ALAMEDA COUNTY
HEALTH CARE SERVICES

August 30, 2007

Subject: Fuel Leak Case No. RO0000207 and Geotracker Global ID T0600102092, Mission Valley Rock and Asphalt, 7999 Athenour Way, Sunol, CA 94586

Alameda County Environmental Health (ACEH) staff has reviewed the fuel leak case file for the above-referenced site including the recently submitted report entitled, "Work Plan to Conduct a Groundwater Remediation Pilot Test at the Asphalt Plant and Additional Subsurface Characterization in the Former Diesel Spray Area, Hansen Aggregates Mission Valley Rock Facility," dated August 3, 2007 and prepared on your behalf by LFR Inc. The Work Plan proposes a scope of work to conduct a groundwater remediation pilot test near well cluster MW-9 and conduct additional characterization in the vicinity of the former diesel spray area. The proposed scope of work is acceptable and may be implemented provided that the technical comments below are addressed during the proposed field investigation. Submittal of a revised Work Plan is not required unless an alternate scope of work outside that described in the Work Plan and technical comments below is proposed.

Site Plan Showing Existing and Proposed Nested Well Locations
 Hanson Aggregates, Sunol, California
 LFR Figure 2

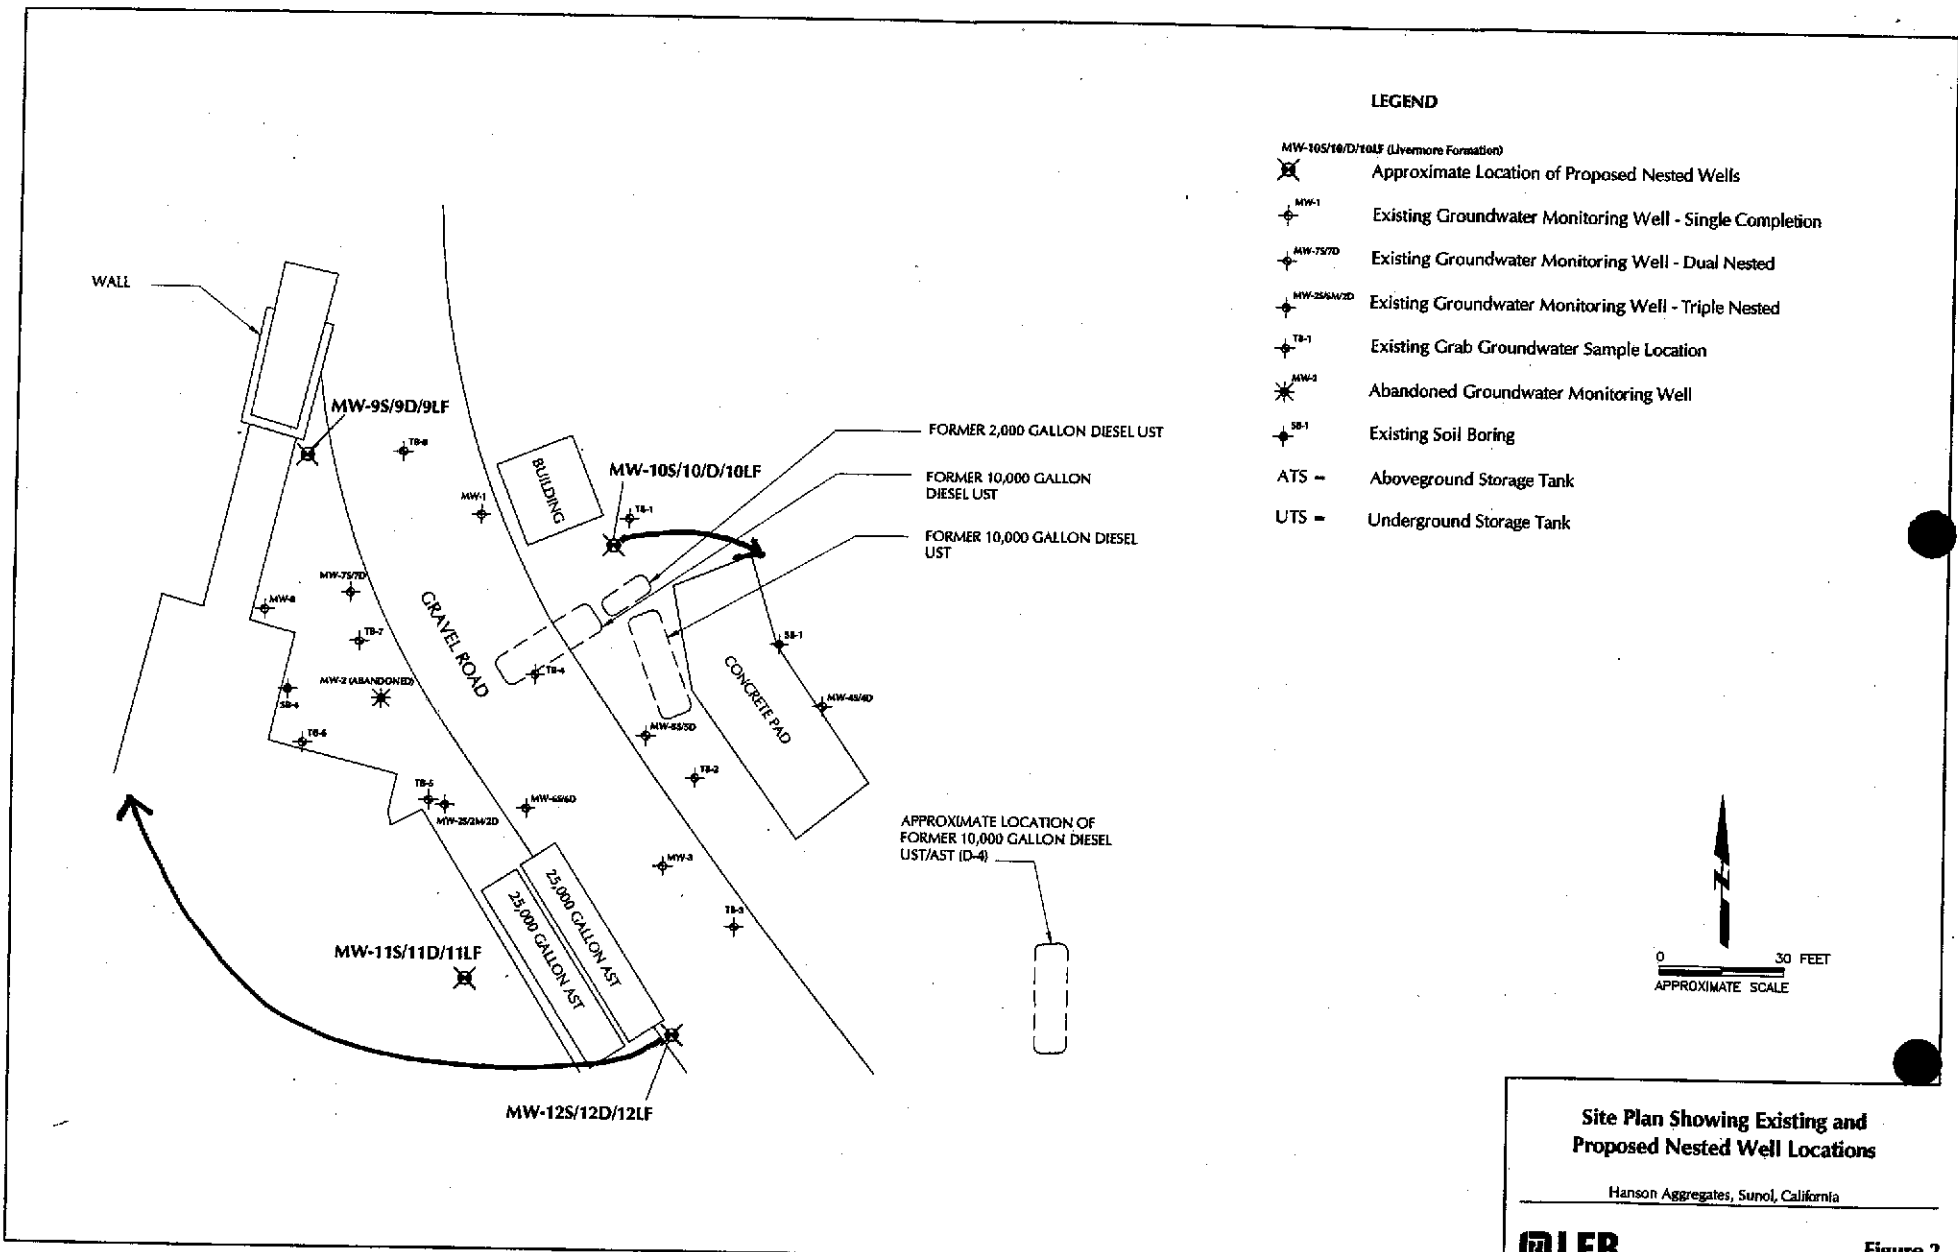
- 2. Plume Delineation to the East.** Because the predominant hydraulic gradient is apparently to the east, we request that proposed monitoring well cluster MW-10S/10D/10LF be moved to a location east of the former underground storage tanks (USTs) as shown on the attached figure.

3. **Plume Delineation to the West.** We request that proposed monitoring well cluster MW-12S/12D/12LF be moved to a location west of the former underground storage tanks (USTs) and monitoring well MW-7D. During recent groundwater monitoring events, elevated concentrations of petroleum hydrocarbons have been detected in groundwater samples from well MW-7D. The screen interval for well MW-8 is too shallow to monitor the deeper water-bearing zone. Therefore, we request that well cluster 12S/12D/12LF be installed to define plume extent to the west as shown on the attached figure.

8. **Figure 2.** Figure 2 depicts the former 2,000-gallon UST as a diesel UST although the text and historical records indicate the UST was used to store gasoline. Please revise Figure 2 or the text accordingly in future reports.

SITE PLAN

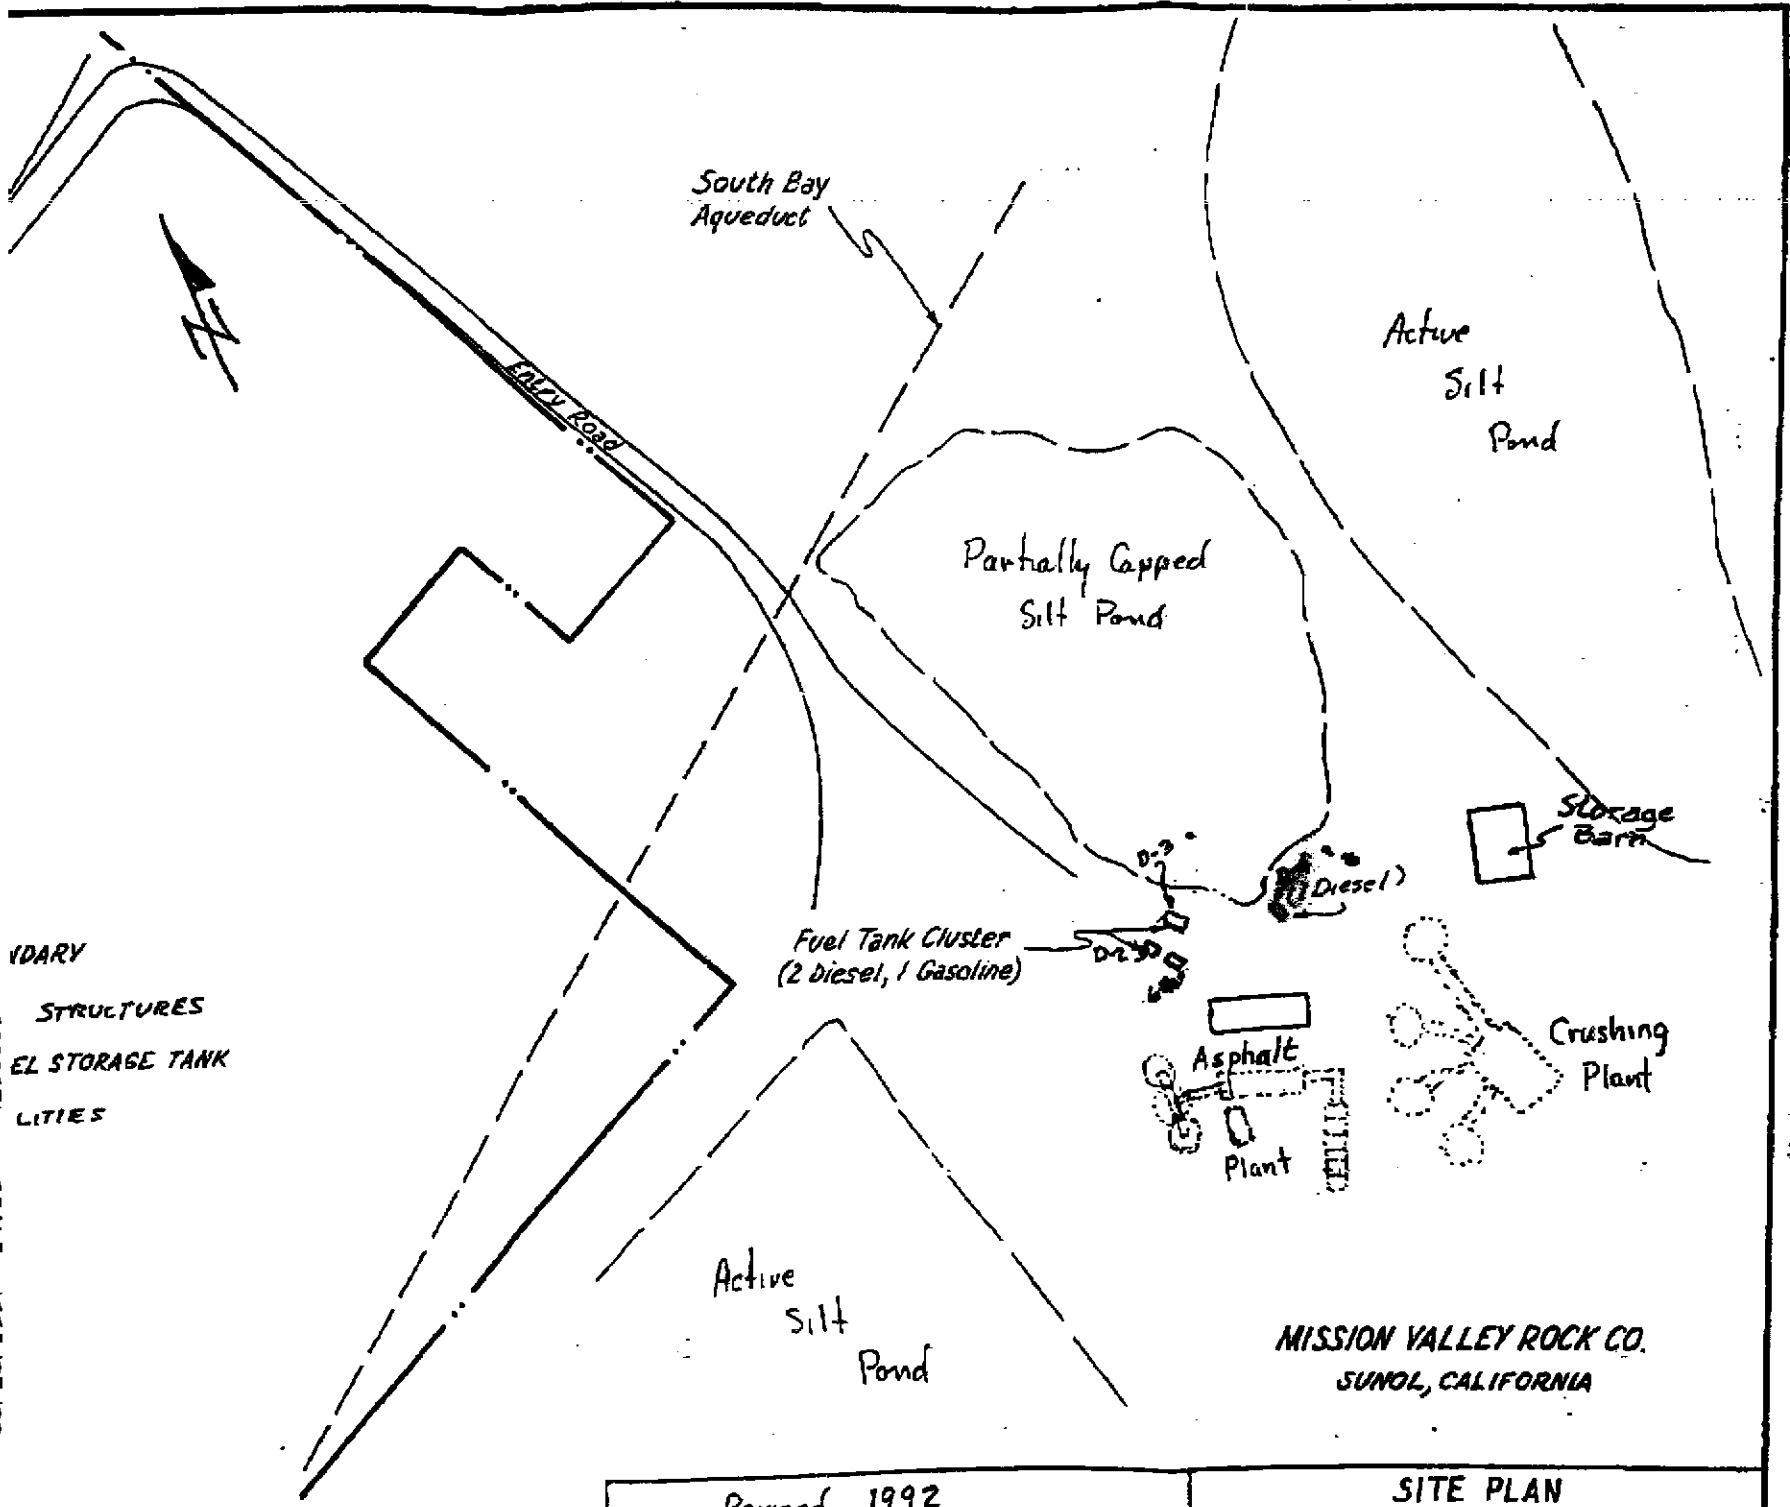
Diesel Tank D-4 is shown on this 1992 site Plan as oriented North/South. Storage Barn is skewed towards northeast about 30°?

Workplan Figure ~~1~~² shows the D-4 Tank North/South but north arrow of tank should be rotated west to agree with Storage Barn
